Monroe Power Project

Informational Packet

Monroe Power Q&A From Board Members/Public

CONDITIONS TO ISSUE AN IMPROVEMENT LOCATION PERMIT
FOR THE MONROE POWER PROJECT

SITE PLAN

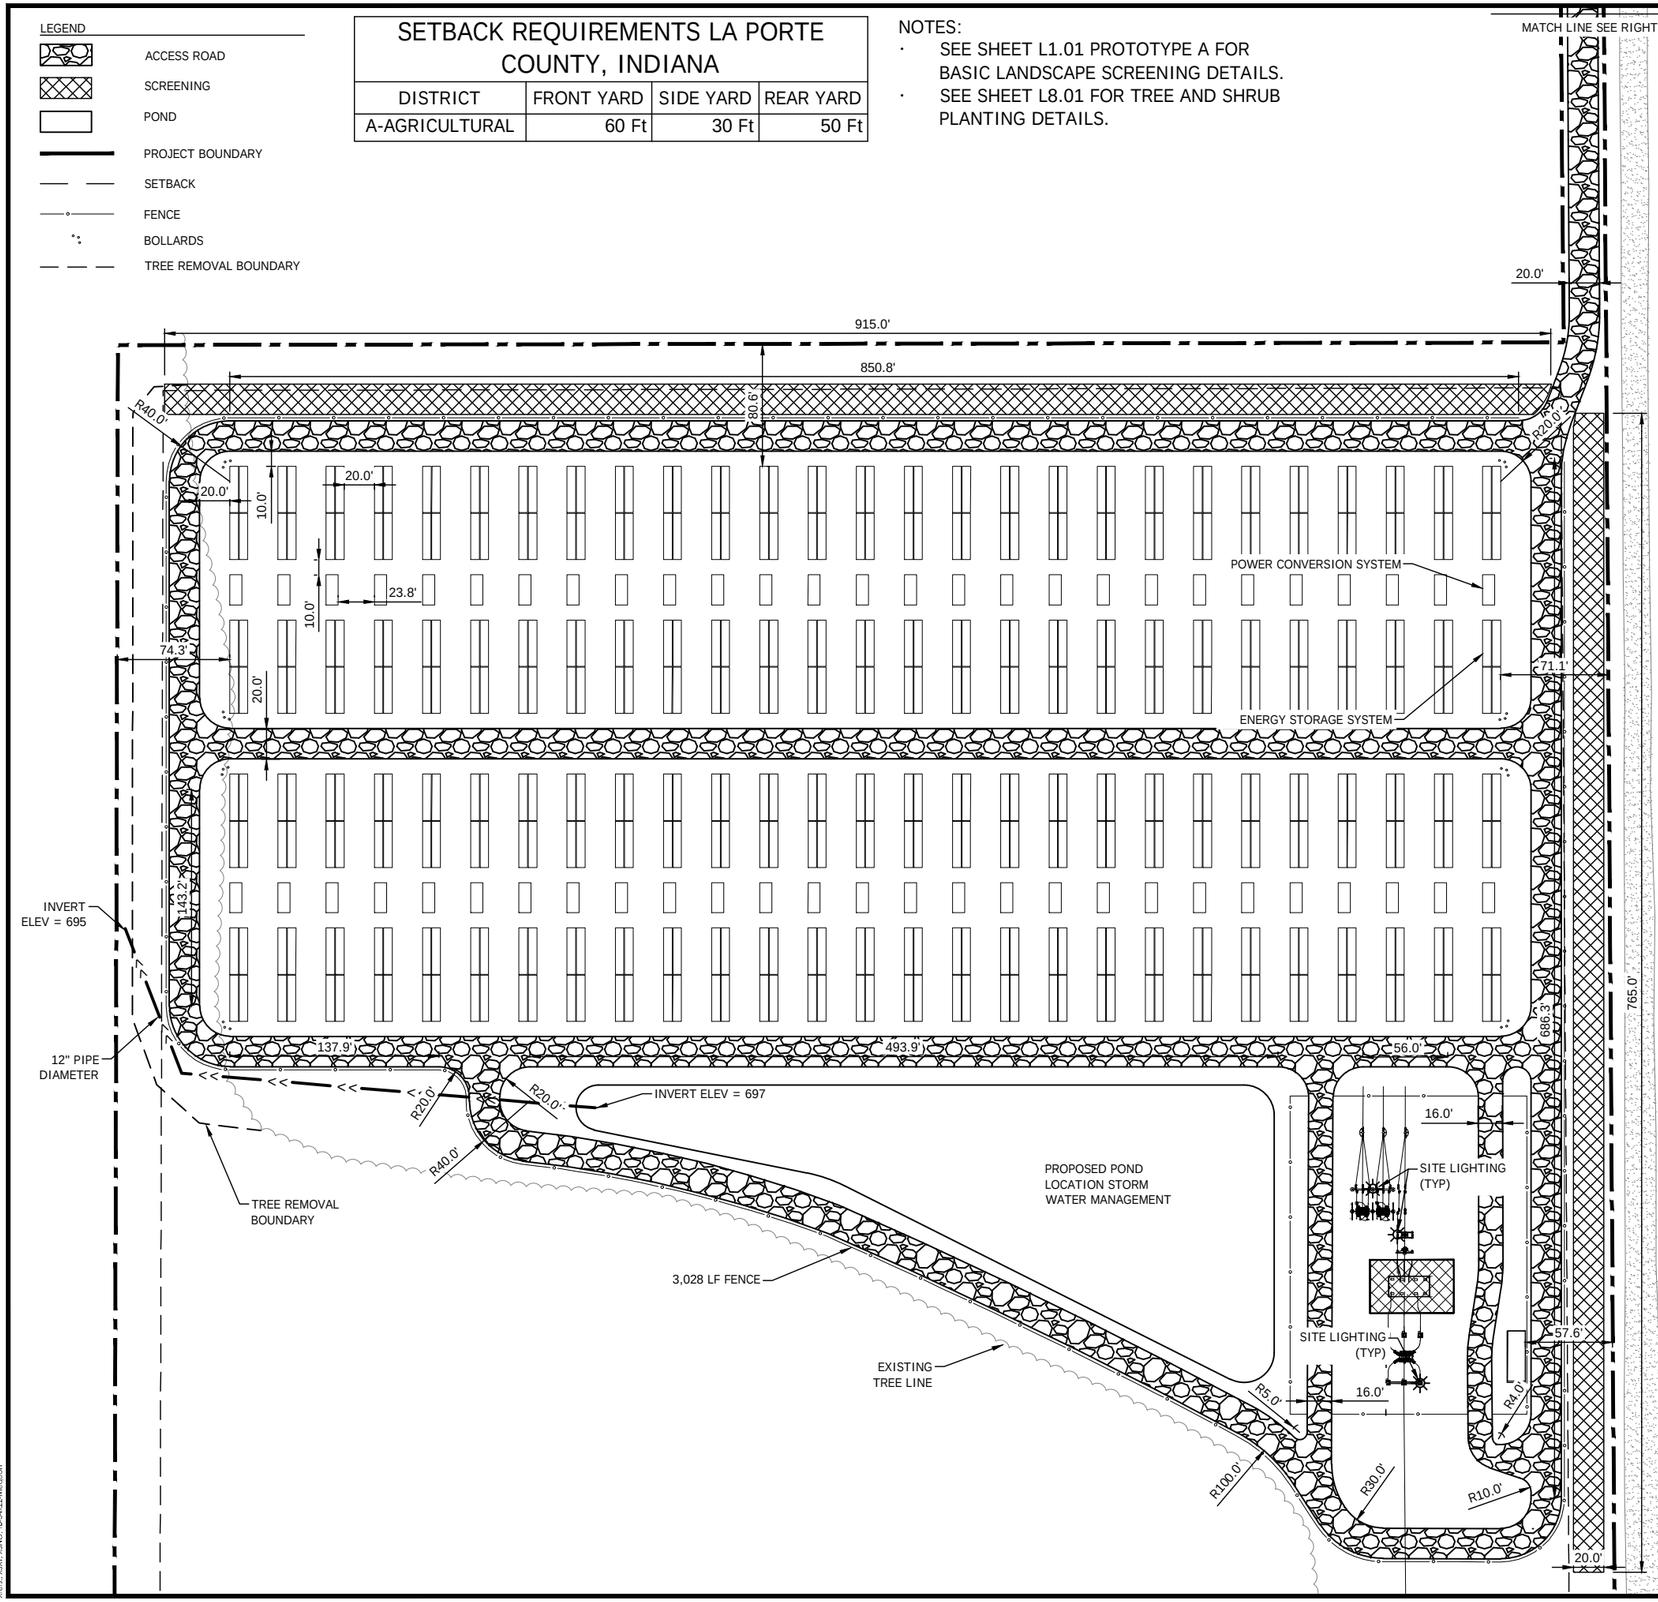
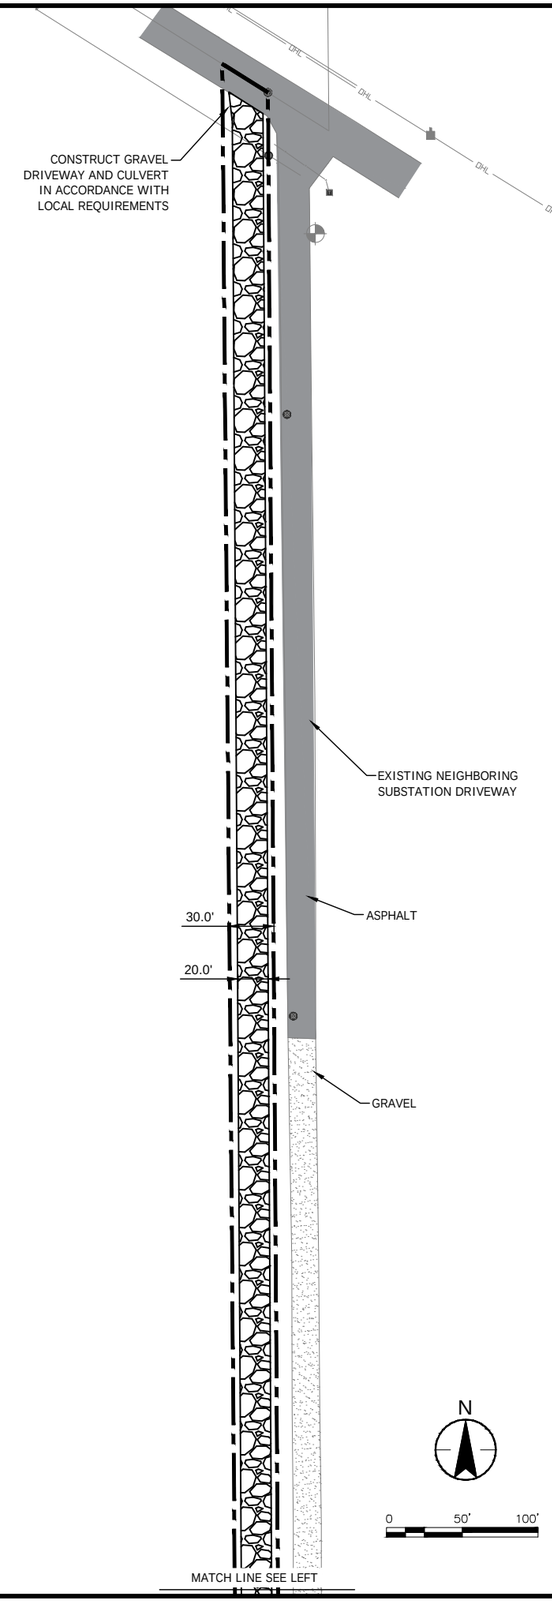
Question: Where would any broken/malfunctioning batteries be stored on site before being removed, and what is at risk of being spilled from Li-ion batteries?

Answer: Any broken or defective batteries would be placed into a sealed temporary storage bin onsite until they are periodically removed from the site for recycling or disposal. The temporary storage bin location has not been specified on the current site plan but would be on the final site plan once specific equipment and final design has been finalized and prepared for the land disturbance permit. The temporary storage bin would be sealed and would not be a large feature of the facility. There are no liquids that can be spilled from Li-ion batteries.
